SERVICE BULLETIN

N° 189-294

ATA 56 - GLASS WINDSHIELD RETROMOD

Figure 1

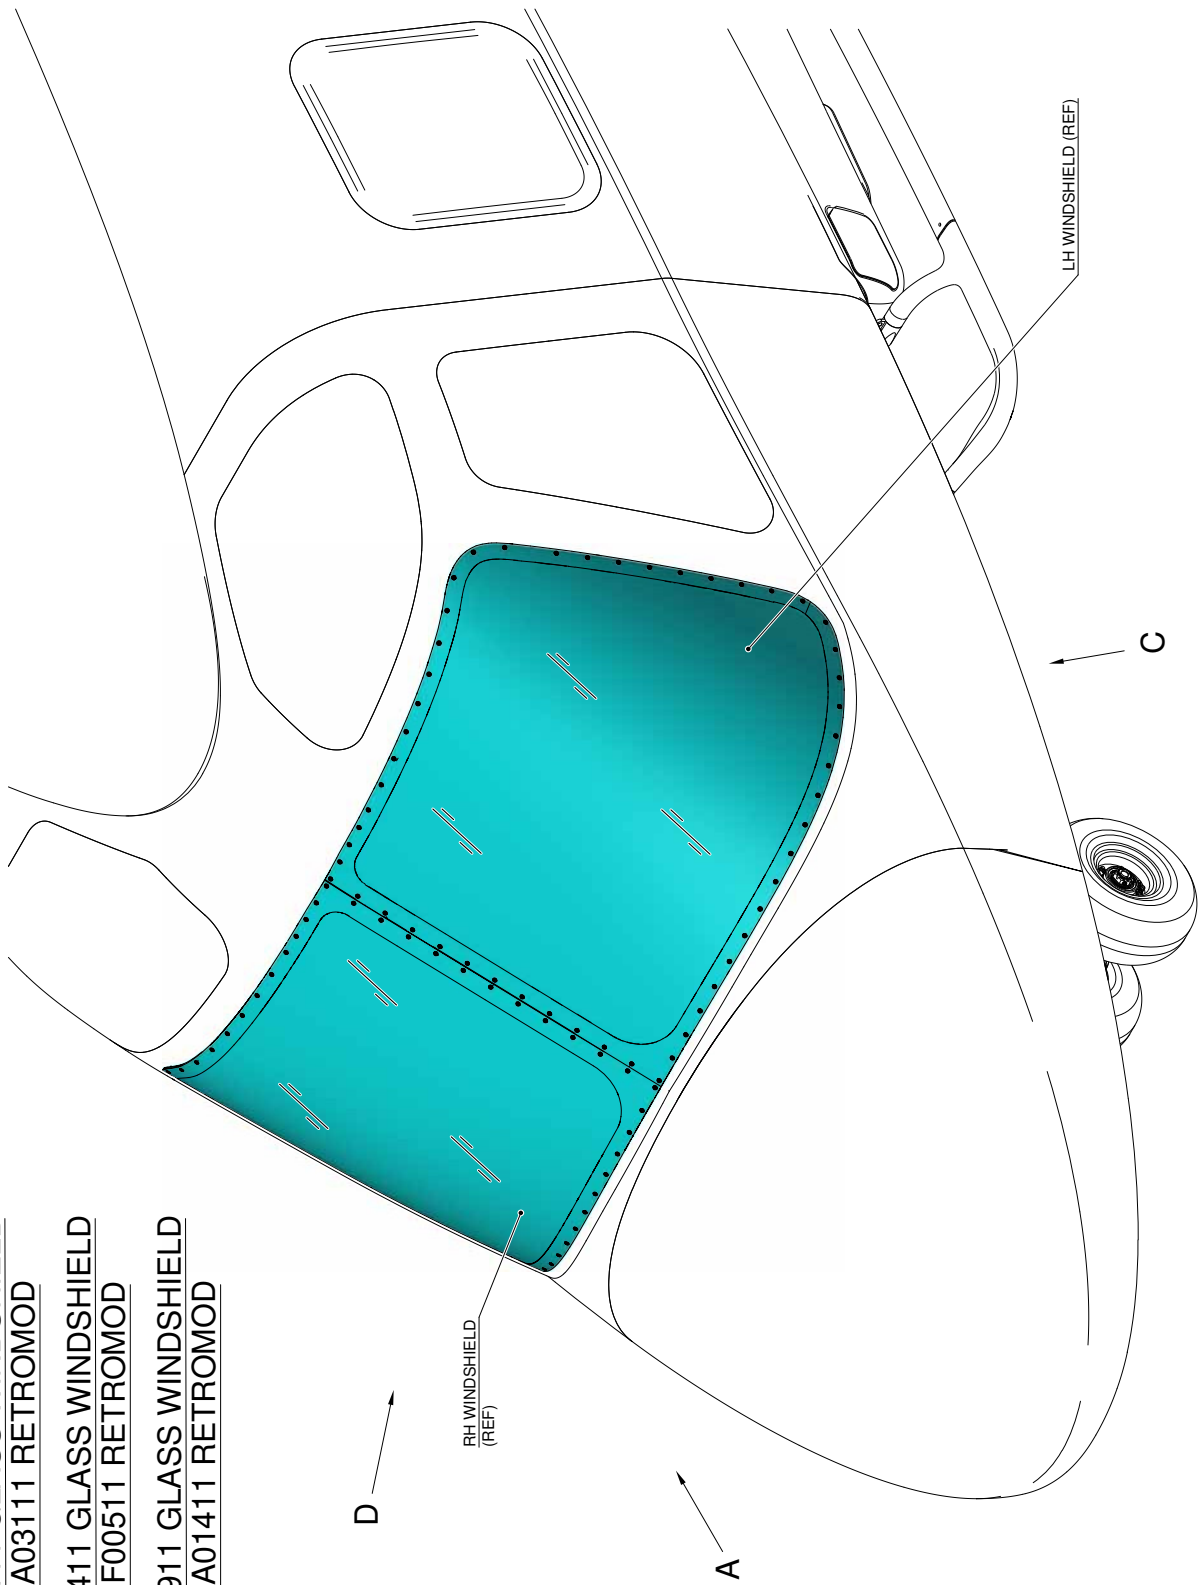
3. Remove remaining material from the canopy surface all around the perimeter. Then clean the canopy surface by means of a cleaning solvent (C010).
 4. With reference to Figures 1 and 2, perform rework of the LH windshield as described in the following procedure:

7. Remove remaining material from the canopy surface all around the perimeter. Then clean the canopy surface.
8. With reference to Figures 1 and 2, perform rework of the RH windshield as described in the following procedure:

VIEW A

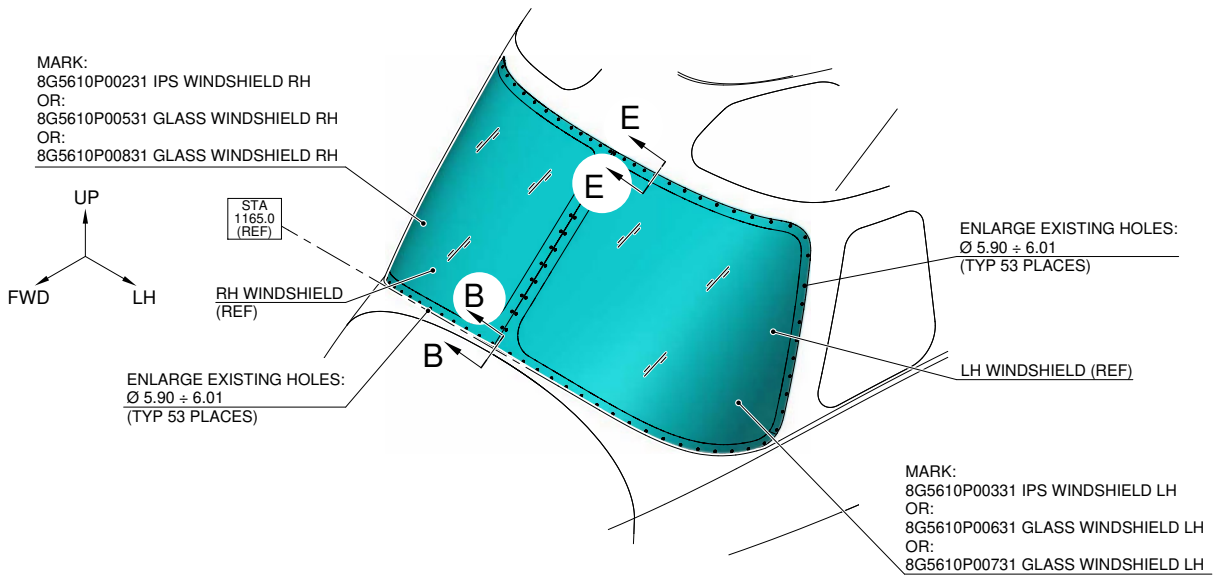
- 4.1 With reference to Figure 2 View A, enlarge n°53 screw holes in the windshield to Ø 5.90 - 6.01. Use the special reamer P/N A05900AAR.
 - 4.2 With reference to Figure 2 Section E-E, verify if the LH windshield is in contact with canopy surface.

- 4.5 With reference to Figure 2 View A, mark on the reworked windshield the following retromod P/N adjacent to the already present P/N. Use an indelible pen.

- 8.1 With reference to Figure 2 View A, enlarge n°53 screw holes in the windshield to \varnothing 5.90 - 6.01. Use the special reamer P/N A05900AAR.
 - 8.2 With reference to Figure 2 Section E-E, verify if the RH windshield is in contact with canopy surface.

SECTION B-B

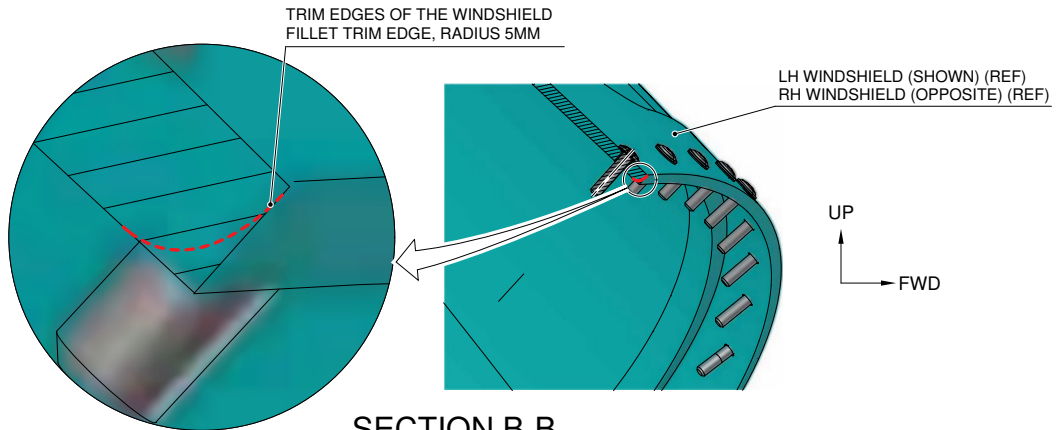
- 4.4 With reference to Figure 2 Section B-B, to ensure proper windshield seating against canopy structure fillet trim edge radius of 5mm by means of abrasive paper (medium grit).

- 8.4 With reference to Figure 2 Section B-B, to ensure proper windshield seating against canopy structure fillet trim edge radius of 5mm by means of abrasive paper (medium grit).
- 8.5 With reference to Figure 2 View A, mark on the reworked windshield the following retromod P/N adjacent to the already present P/N. Use an indelible pen.
 - P/N 8G5610P00231 on RH windshield P/N 4G5610V00231;
 - P/N 8G5610P00531 on RH windshield P/N 3G5610V00451;
 - P/N 8G5610P00831 on RH windshield P/N 3G5610V00251.

SECTION E-E

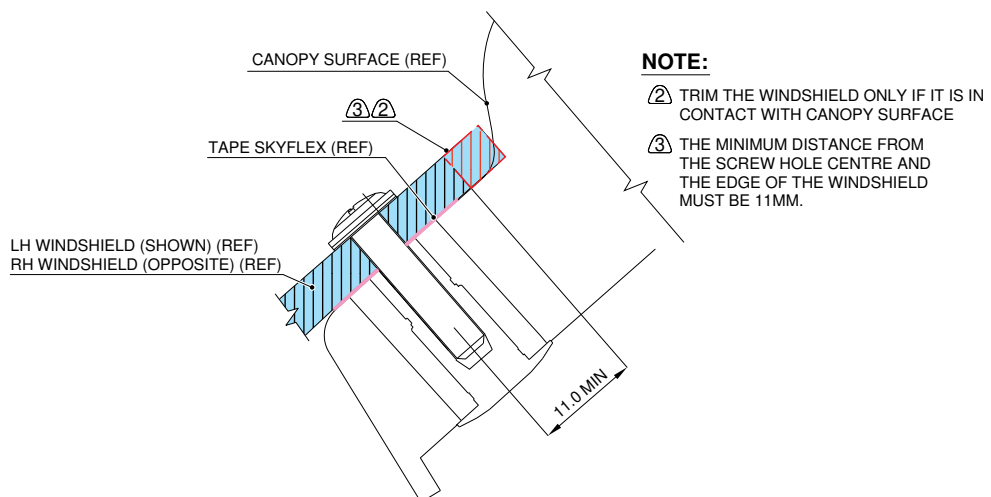
- 4.3 With reference to Figure 2 Section E-E, trim the LH windshield in the position where the windshield is in contact with the canopy structure in order to remove the interference. Use abrasive paper (medium grit).

- 8.3 With reference to Figure 2 Section E-E, trim the RH windshield in the position where the windshield is in contact with the canopy structure in order to remove the interference. Use abrasive paper (medium grit).

Figure 3

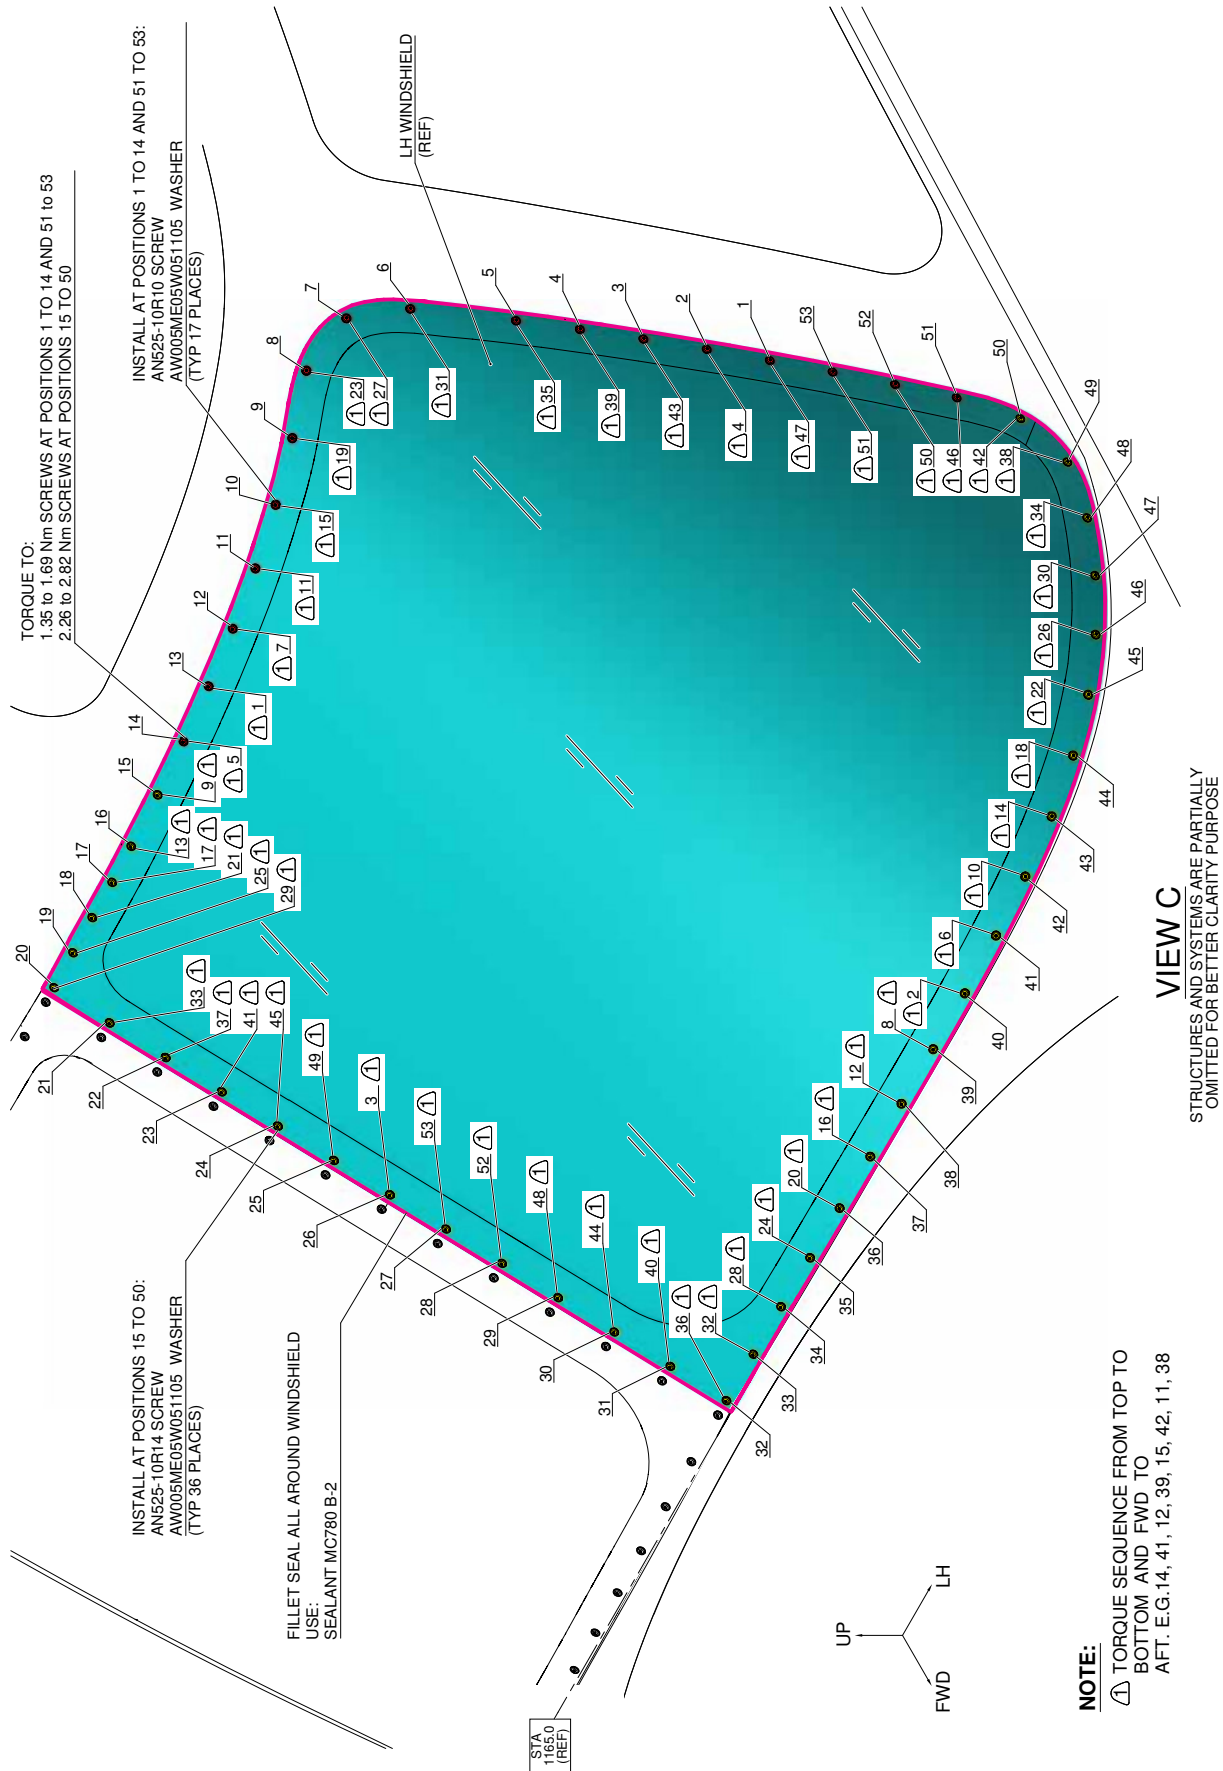
- 5.2 With reference to Figure 3 View C, pin windshield at positions 2 and 26. Install fasteners loosely at this time. Do not torque.
- 5.3 With reference to Figure 3 View C, pin windshield at positions 13 and 40. Install fasteners loosely at this time. Do not torque.

- 5.5 With reference to Figure 3 View C, hand tighten screws at positions 13 and 40 until the windshield is clamped. Do not fully torque at this time.
- 5.6 With reference to Figure 3 View C, hand tighten screws at positions 2 and 26 until the windshield is clamped. Do not fully torque at this time.

- 5.7 With reference to Figure 3 View C, install all other fasteners loosely, but do not fully torque. Use the following sequence from top to bottom and forward to aft (e.g. 14, 41, 12, 39, 15, 42, 11, 38). Once all screws are in position, tighten them in the same order.

- 5.8 With reference to Figure 3 View C tighten the fasteners to the following final torque values with the same sequence used in the previous step:
 - 1.35 to 1.69 Nm for screws at positions 1 to 14 and 51 to 53;

- 2.26 to 2.82 Nm for screws at positions 15 to 50.

- 5.9 With reference to Figure 3 View C, apply a bead of sealant MC780 B-2 all around the windshield perimeter.
- 5.10 In accordance with the applicable AMP procedure, conclude the installation of the LH windshield as required.

Figure 4

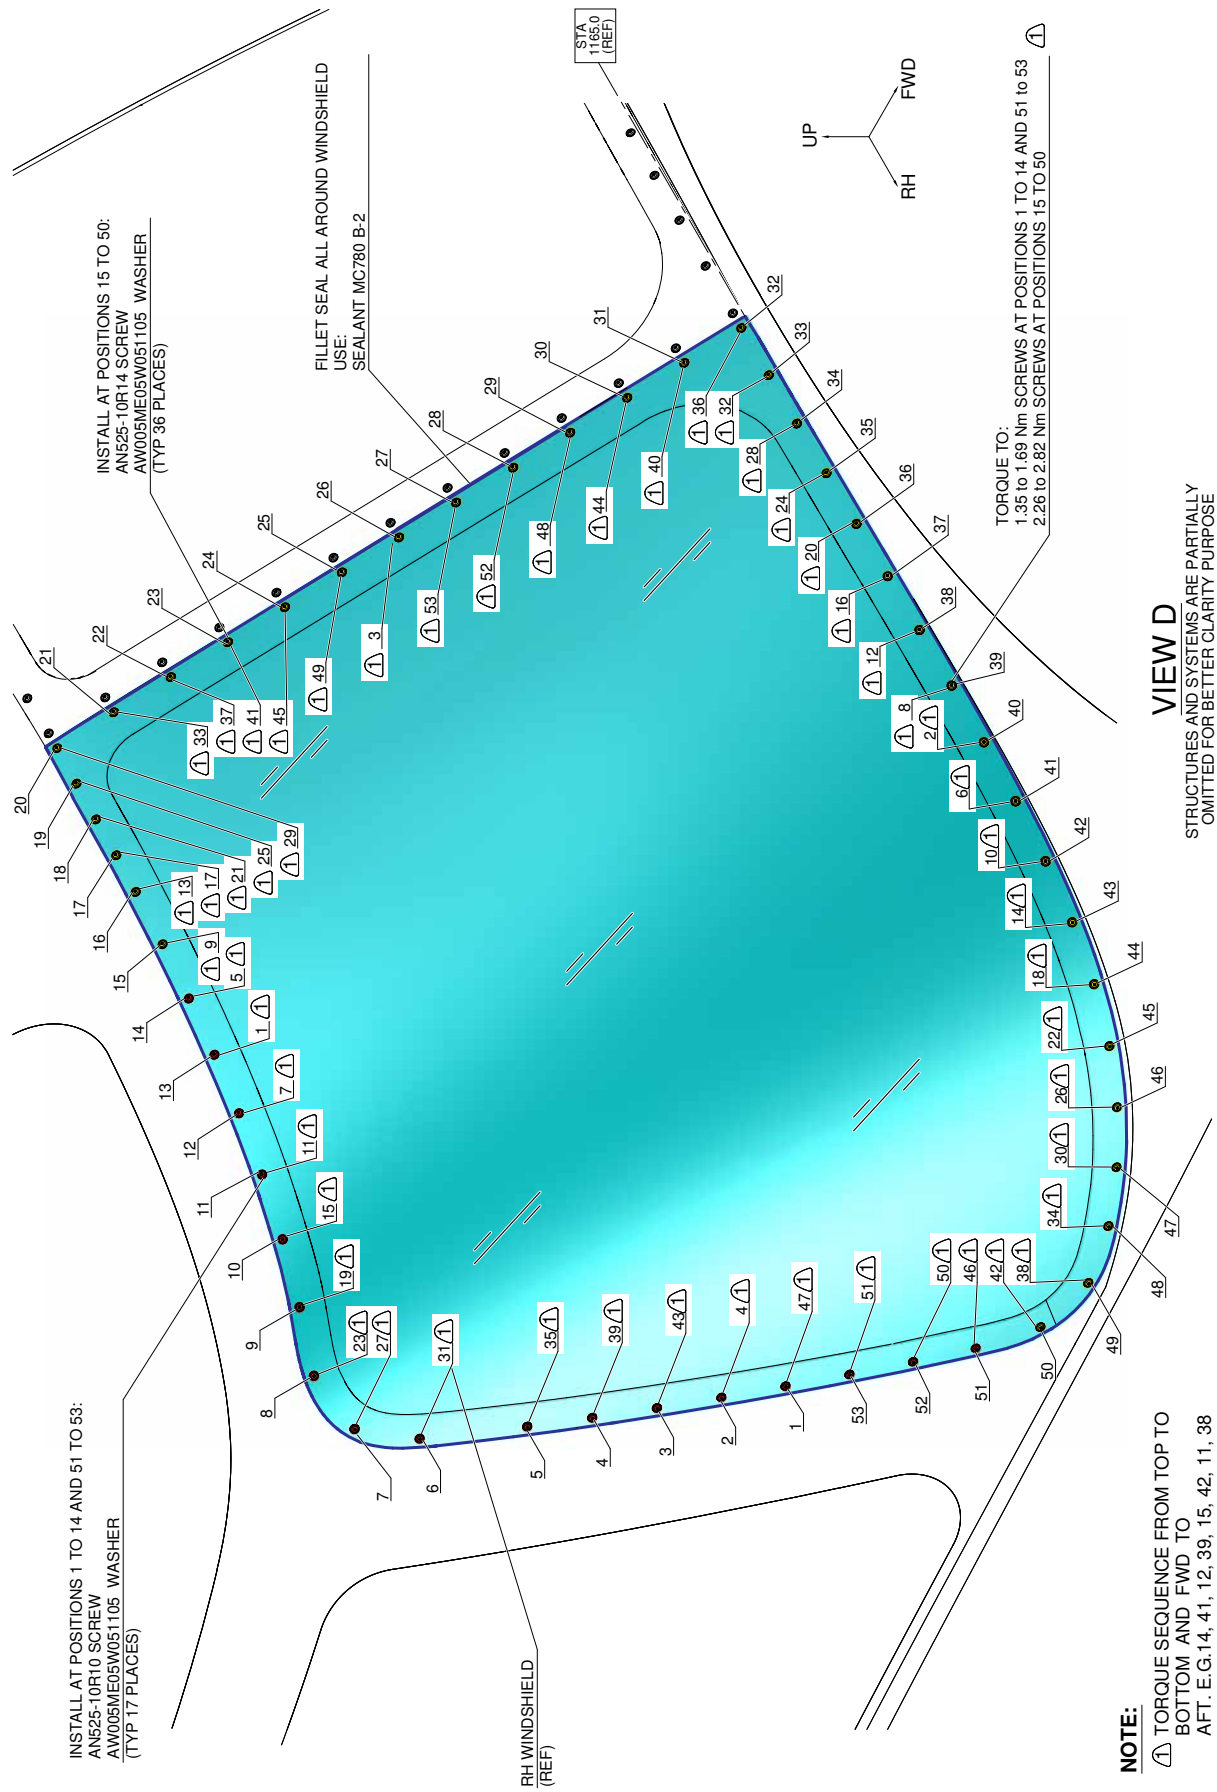
- 9.2 With reference to Figure 4 View D, pin windshield at positions 2 and 26. Install fasteners loosely at this time. Do not torque.
- 9.3 With reference to Figure 4 View D, pin windshield at positions 13 and 40. Install fasteners loosely at this time. Do not torque.

- 9.6 With reference to Figure 4 View D, hand tighten screws at positions 2 and 26 until the windshield is clamped. Do not fully torque at this time.
- 9.7 With reference to Figure 4 View D, install all other fasteners loosely, but do not fully torque. Use the following sequence from top to bottom and forward to aft (e.g. 14, 41, 12, 39, 15, 42, 11, 38). Once all screws are in position, tighten them in the same order.

- 9.8 With reference to Figure 4 View D, tighten the fasteners to the following final torque values with the same sequence used in the previous step:
 - 1.35 to 1.69 Nm for screws at positions 1 to 14 and 51 to 53;

- 2.26 to 2.82 Nm for screws at positions 15 to 50.
- 9.9 With reference to Figure 4 View D, apply a bead of sealant MC780 B-2 all around the windshield perimeter.
